CHARLES CITY

AGRICULTURAL

SUPER 55 NEW SWINGING DRAWBAR

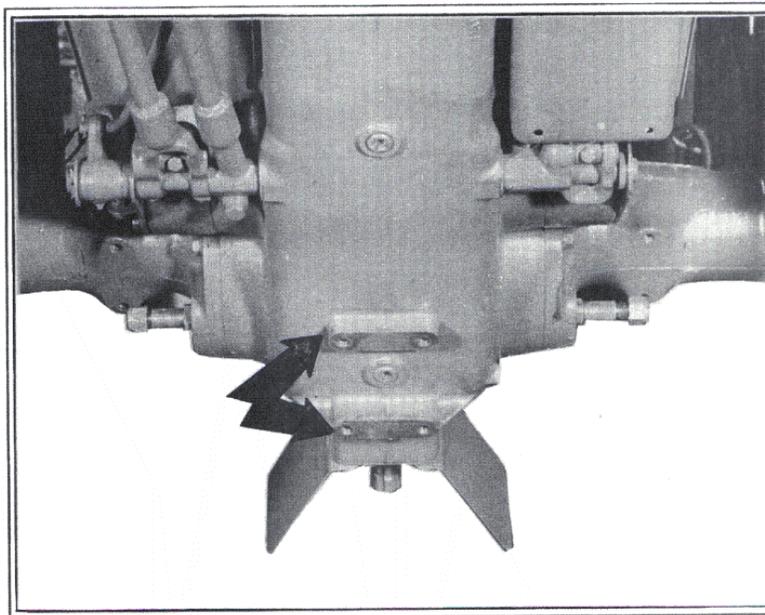
Effective with Super 55 tractor serial number 52 814-519 a new swinging drawbar has been released. This drawbar assembly is not interchangeable with previous Super 55 tractors due to the method of attachment to the rear frame.

Beginning with tractor serial number 52 814-519, two bosses were added to the bottom of the rear frame (see illustration) so that certain Ford and Ferguson equipment could be used with the Super 55. With the introduction of these bosses, it became evident we had a logical place to attach our swinging drawbar.

The original swinging drawbar was attached to the tractor by a support bracket at each rear axle carrier using 1/2-inch diameter cap screws. The new swinging drawbar attaches to a single support bracket which is mounted on the new bosses by 5/8-inch diameter cap screws.

This new drawbar assembly mounting with the heavier cap screws should also help eliminate the cases where the 1/2-inch cap screws were being sheared off.

- 25-P-52 Package for all Super 55 tractors with serial number 6 001-518 through 52 813-519.
- 25-P-66 Package for all Super 55 tractors from serial number 52 814-519 and up.
